Notification# 20180417000
Datasheet for AM26LV31
Information Only

PCN Number:	20180417000	**PCN Date:**	May 14, 2018
Title:	Datasheet for AM26LV31 ☐		
Customer Contact:	PCN Manager	**Dept:**	Quality Services
Proposed 1st Ship Date:	Aug 14, 2018		
Change Type:

AM26LV31

SLLS201H – MAY 1995 – REVISED APRIL 2018

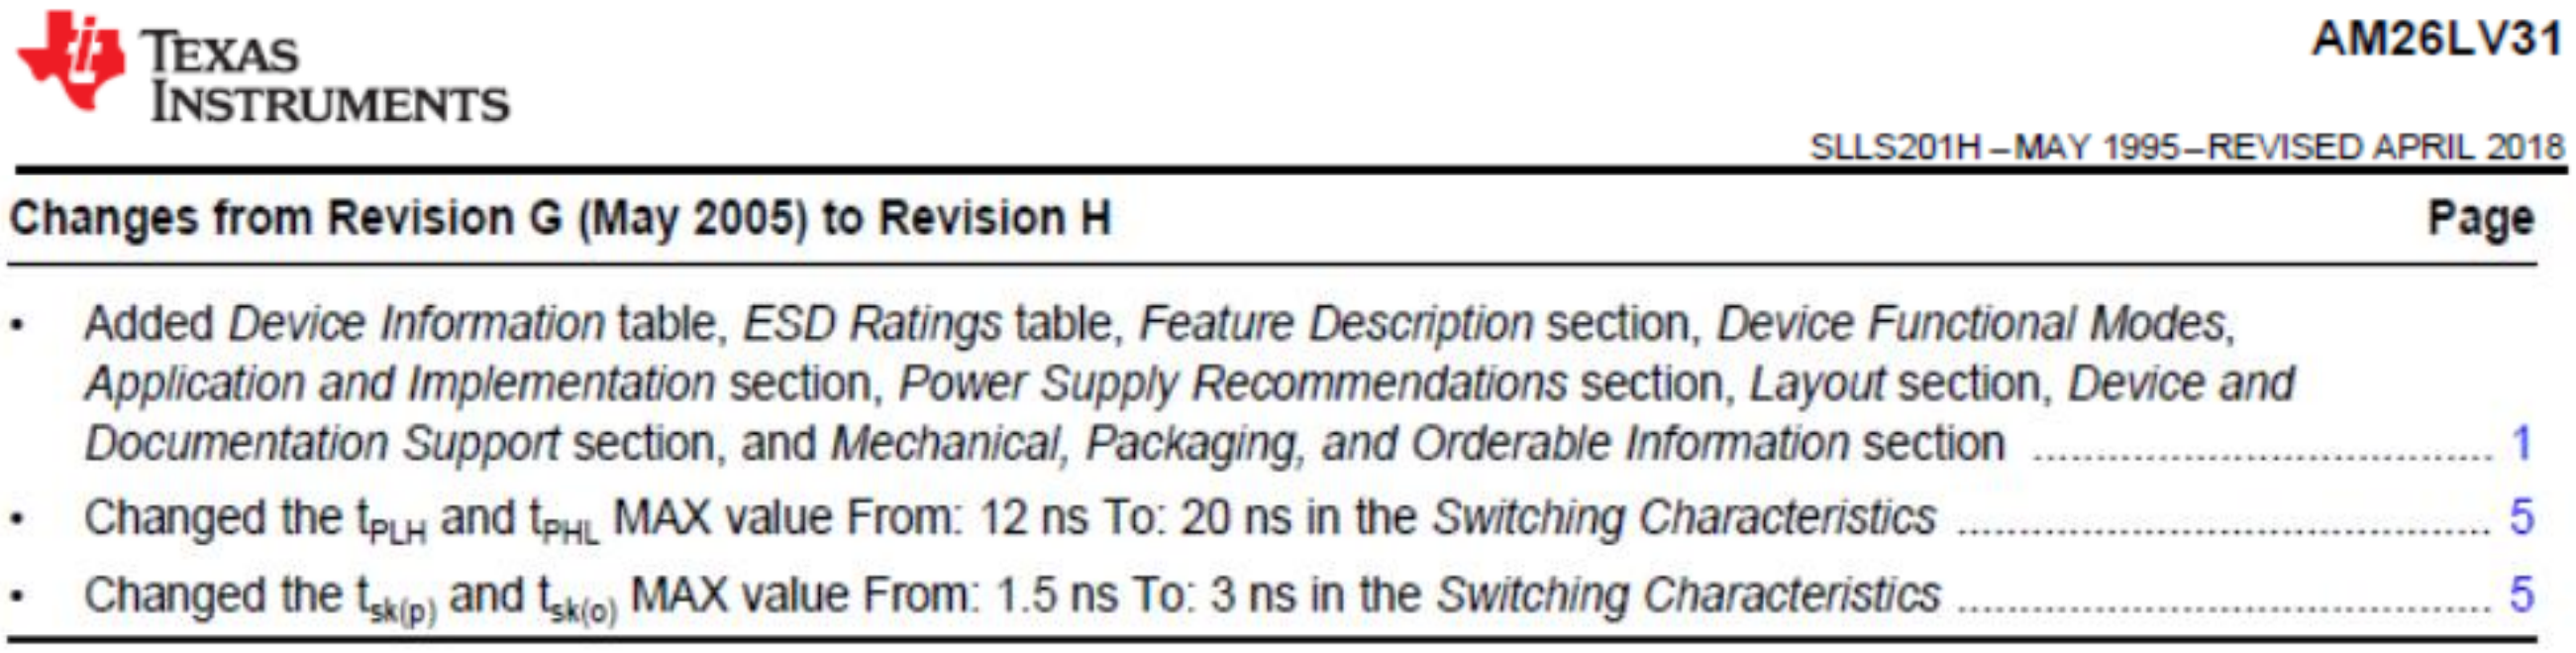
Changes from Revision G (May 2005) to Revision H **Page**

- Added *Device Information* table, *ESD Ratings* table, *Feature Description* section, *Device Functional Modes*, *Application and Implementation* section, *Power Supply Recommendations* section, *Layout* section, *Device and Documentation Support* section, and *Mechanical, Packaging, and Orderable Information* section 1
- Changed the t_{PLH} and t_{PHL} MAX value From: 12 ns To: 20 ns in the *Switching Characteristics* 5
- Changed the $t_{sk(p)}$ and $t_{sk(o)}$ MAX value From: 1.5 ns To: 3 ns in the *Switching Characteristics* 5
